OUR REF 22022512

RM240388-389 & RM200118C: S92 Further Information response.

Figure 1: Lodged Scheme Rev M showing part of Stage 9 and Stage 13

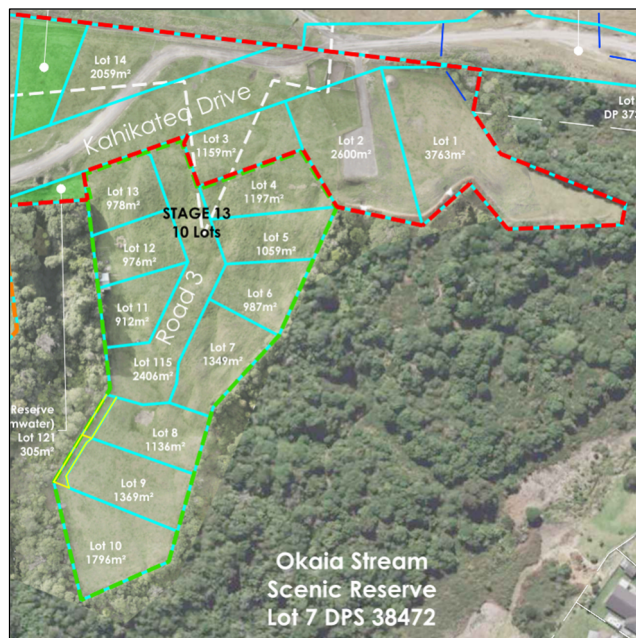
The scheme plan (Enclosure 1) has been amended, and the number of residential lots has reduced to 83. The layout of Lots 1 – 5, 8 - 10 in Stages 9 and 13 were amended to better shaped lots and larger areas for building platforms, reducing the requirement for earthworks within the building setbacks.

Figure 3: Lodged Scheme Rev M showing Lots 63 – 66 in Stage 12

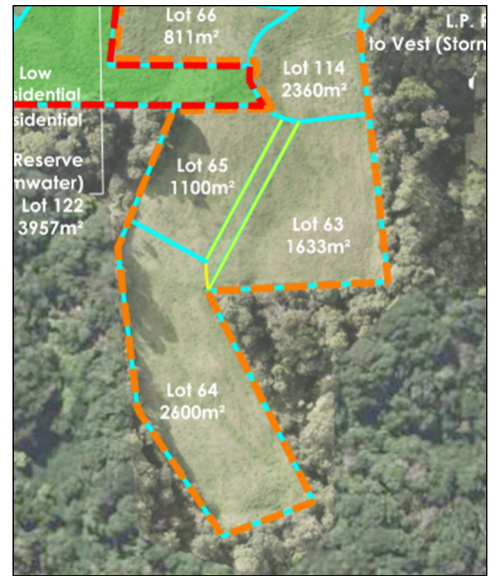
In Stage 12, a lot has been removed, creating a larger building platform on Lot 64.

Figure 5: Lots adjoining stormwater reserve (Lot 122)

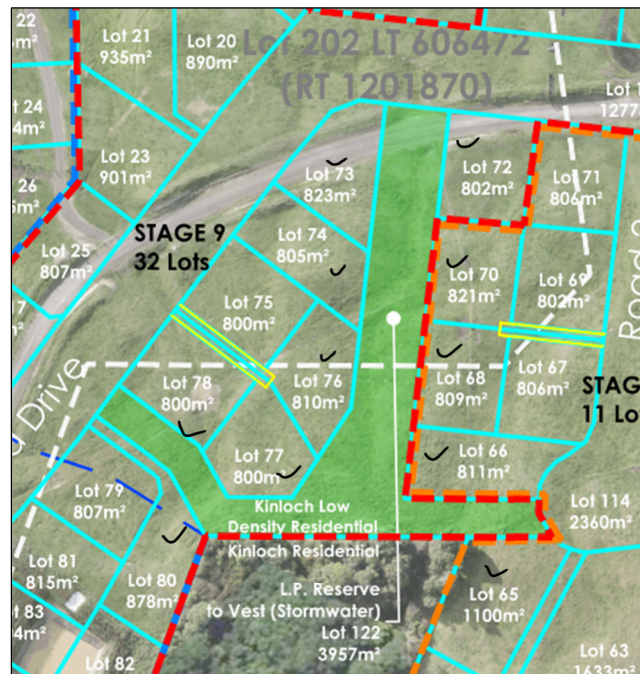
In the area where most lots are 800m² - 900m² there will be 4000m² of open space / passive reserve which will be landscaped with walking paths and vested as stormwater reserve with Taupō District Council. Eleven (11) of the residential lots will have direct frontage onto this reserve space.

Figure 8: Cut / Fill plan

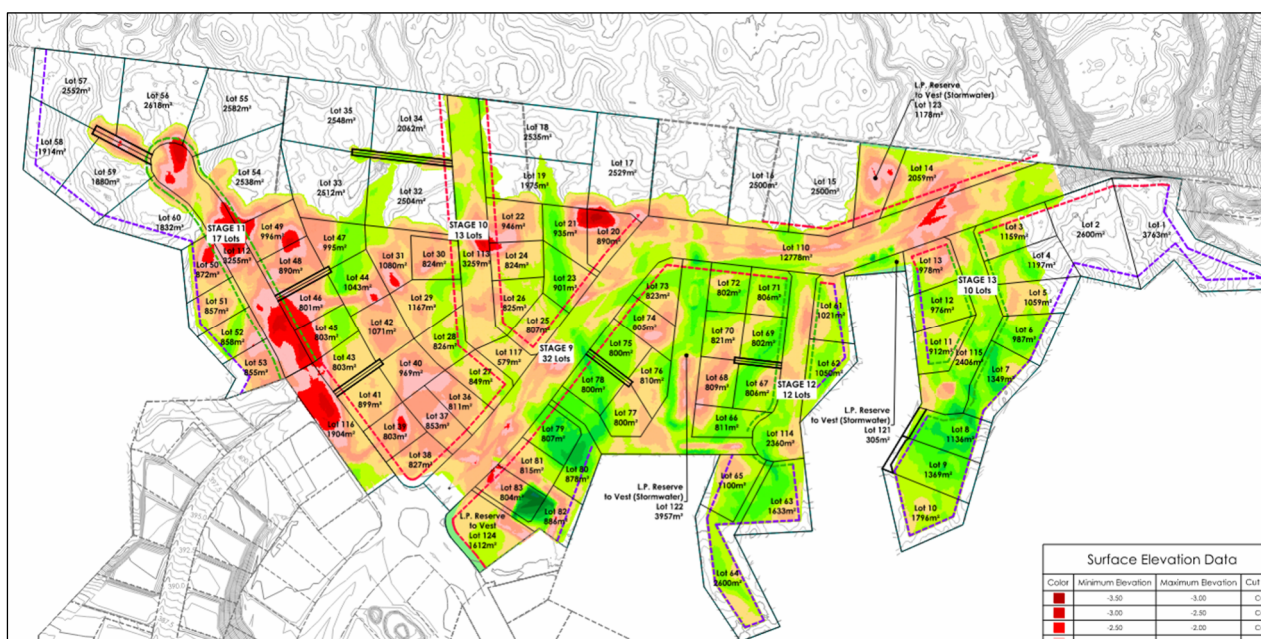
A 7.5m setback from the reserve is considered appropriate in terms of protecting reserves ecological and amenity values, as this is what the district plan specifies as a suitable setback for the Kinloch residential zone adjoining the same reserves, which this layout essentially emulates. The effect of a 2.5m reduction from 10m to 7.5m in this area along with the proposed ecological conditions is considered to have less than minor effect on the ecological and amenity values of the reserve. There will not be extensive earthworks within 7.5m setback from the reserves as demonstrated on the cut/fill plan.

The site has approximately 1.6km of boundary with reserve, of which approximately 478m will require earthworks within the 7.5m setback.

Figure 9: Clustering within subdivision

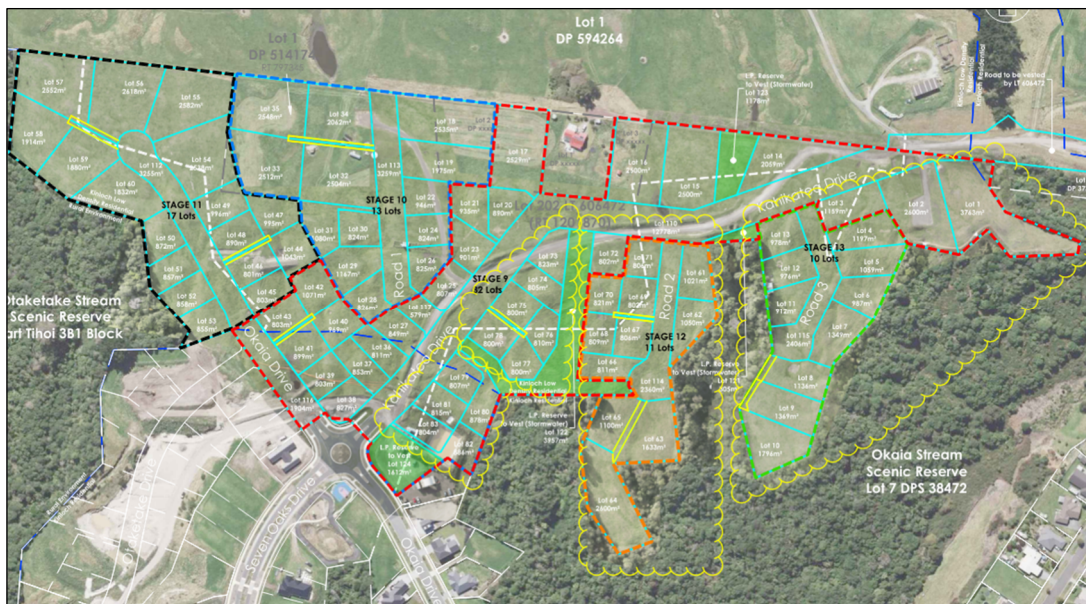
The subdivision is surrounded by scenic reserve which provides a strong existing vegetation framework. Stage 13 is clustered within the Okaia Stream Scenic Reserve. Stage 12 is clustered within the Okaia Stream Reserve and stormwater reserve, and there are clusters of lots within Stage 9 between the stormwater reserve and Okaia Stream Scenic Reserve.
